Urban Design Statement

Campana Road Structure Plan

Information Requests : Urban Design & Open Space

Campana Road Plan Change

Figure 1: Puhinui Precinct (Sheet B-01) Labelled with Open Space Areas.

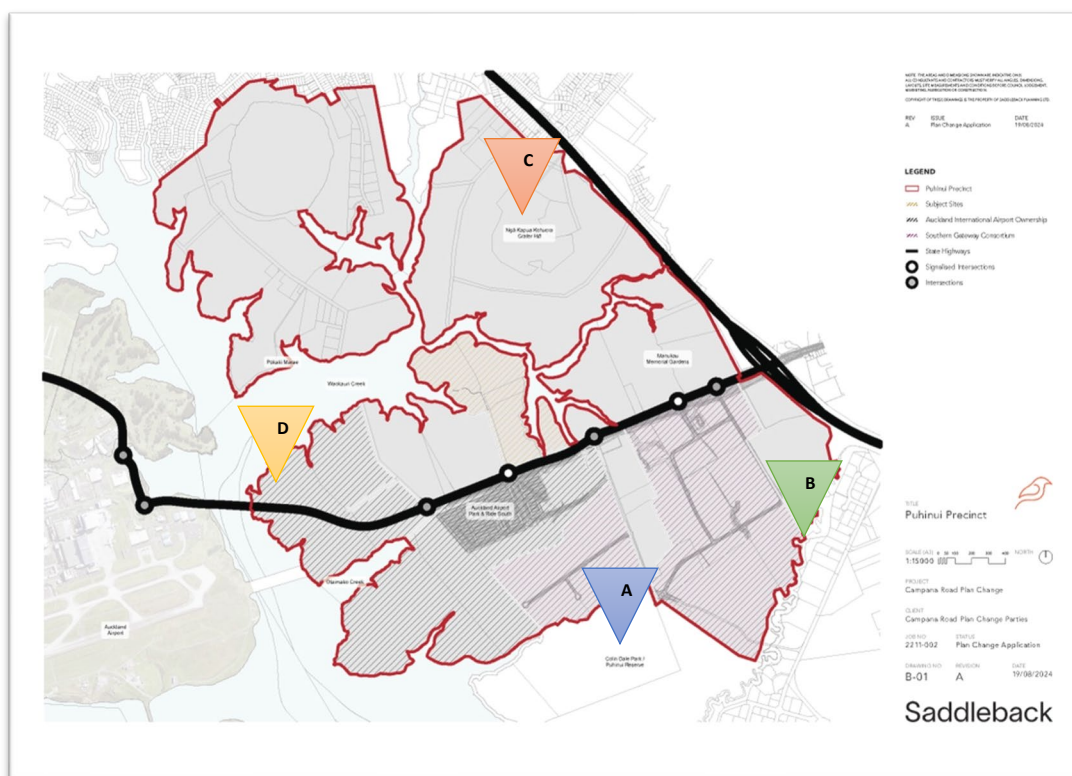
Please demonstrate how Sub-Precinct A might function as open space, how it might link in with existing (and proposed) pedestrian /active transport connections beyond the site (in order to meet the objectives (1), (3) and (4) and policies (1), (3) and (4) within the Puhinui Precinct), and review the appropriate connections to an existing or potential wider network.

The use of sub-precinct C1 for wider public benefit would be contingent on linking it to other amenity areas and creating an integrated network of open space. As shown in plan below existing amenity spaces within the surrounding area (such as Colin Dale Park/Puhinui Reserve (A) and Aerovista Place Reserve (B)) are not within the precinct and have no clear means of connection to the site in question and Crater Hill (C) is in private ownership and is not generally accessible to the public. While the airport has an existing coastal yard to the west, a contiguous coastal pathway through AIAL's landholdings (D) would only occur if AIAL land were subdivided and an esplanade strip established. The record has established that AIAL is not in the habit of subdividing land.

In light of the above, connecting the proposed open space to other amenity areas and making it generally accessible to the public will be heavily reliant on pathway linkages within road reserves.

Figure 2: Open Space and Movement Network (Sheet B-11,).

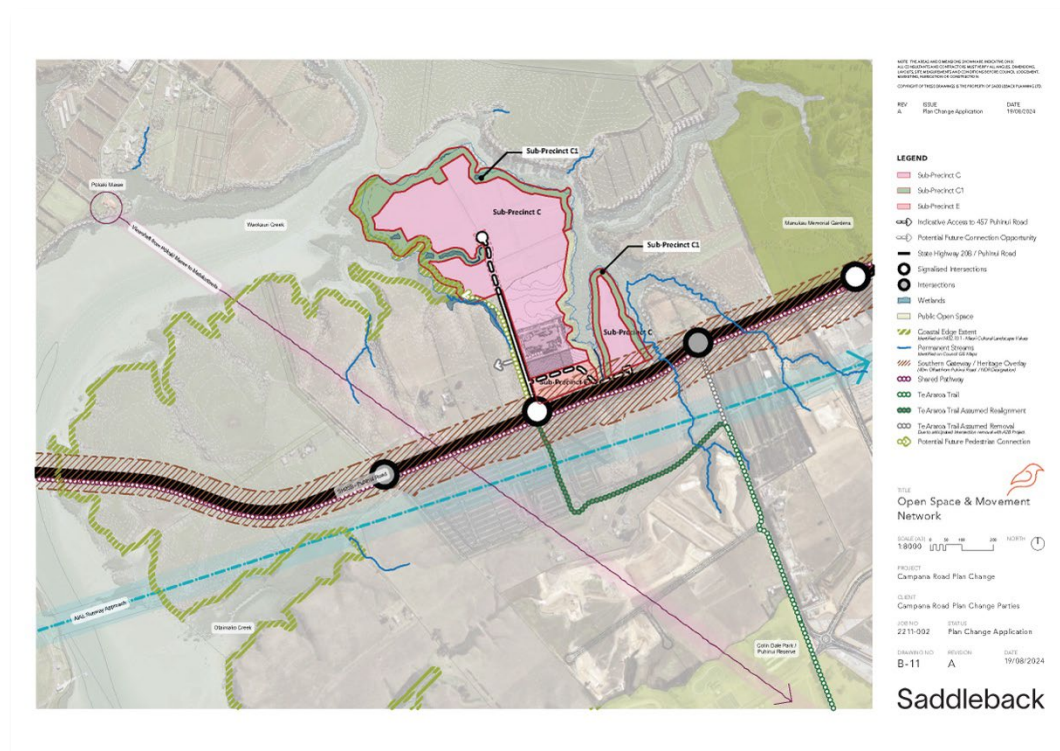
Please provide additional information on what may be the key internal routes for various different transport modes.

There is only one key vehicle route, that being Campana Road itself. Other vehicle routes are simply to provide internal block access. This includes the shorter slip-road east behind Precinct E to 457 Puhinui Road (within the existing SH20B road reserve). The road reserve of Campana Road is wide enough to accommodate a shared bicycle/pedestrian path should AT wish to provide this connection.

As detailed in the plan below (Sheet B-11), the important pedestrian linkages are:

- Those provided within the Campana Road corridor, and;
- Those which can be provided within the riparian margin in future.

The re-entrant gully/tributary to the Waokauri Creek to the west of Campana Road is particularly important to achieving a loop connection, however access is via the private land which is outside the scope of this Plan Change request. As an alternative, a loop connection can be achieved via the indicative northern extension of Campana Road.
